PRELIMINARY/FINAL DRAINAGE REPORT

APPALOOSA HWY 24 SUBDIVISION

FILING NO. 2, LOTS 1, 2 & 3

Drainage calculations have not been reviewed at this time. Due to the fact that the plan and the narrative have multiple discrepancies, please make corrections.

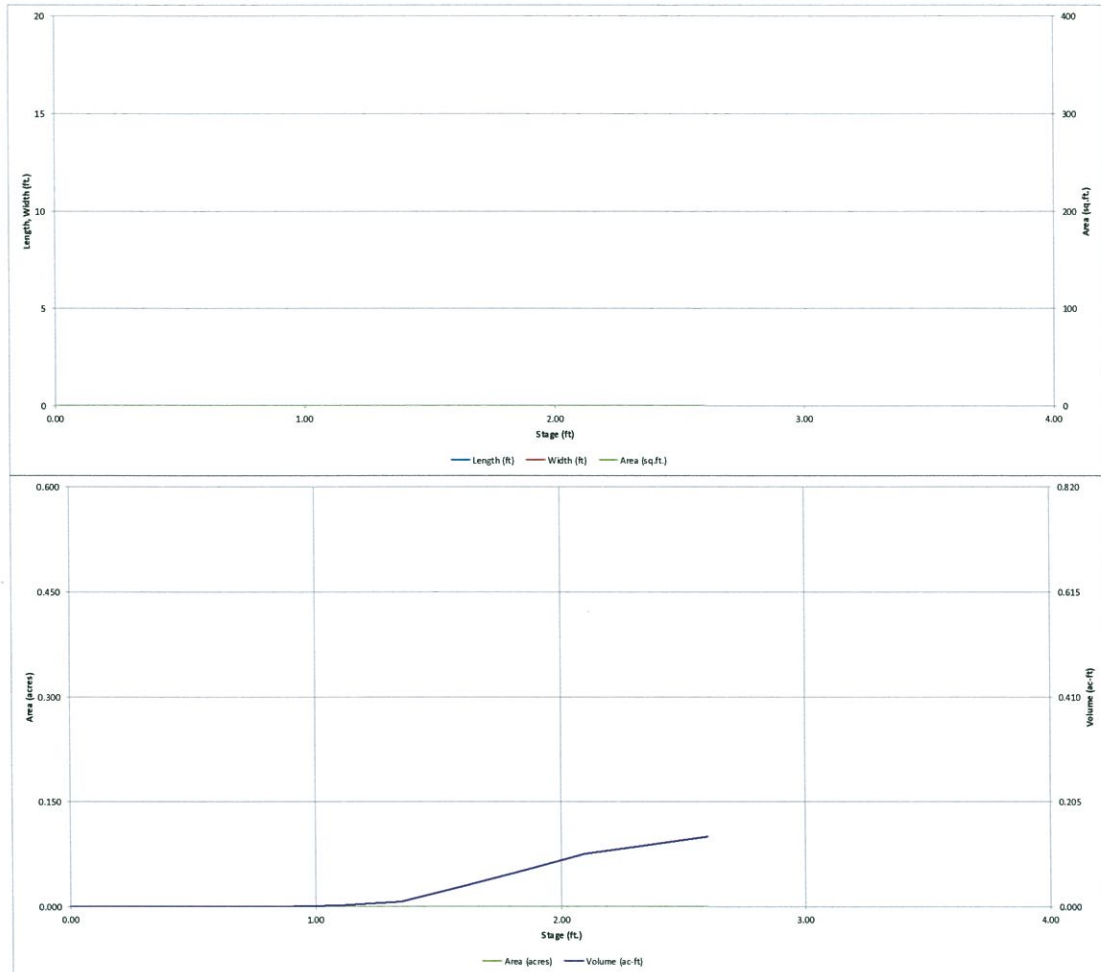
Also include the inverts of all outlets (e.g. vertical orifice, overflow grate, and spillway, where applicable).

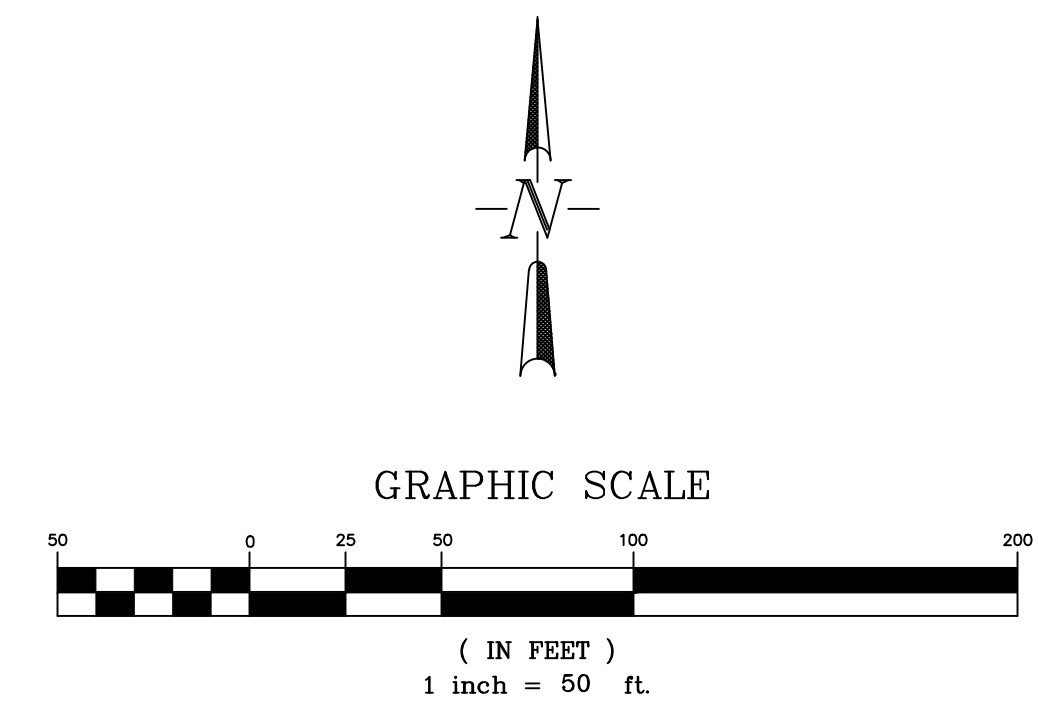
Please clearly show property boundaries.
Please make ownership labels for adjacent parcels readable, as well as other items shaded back.
Please call out who currently owns and maintains this channel.
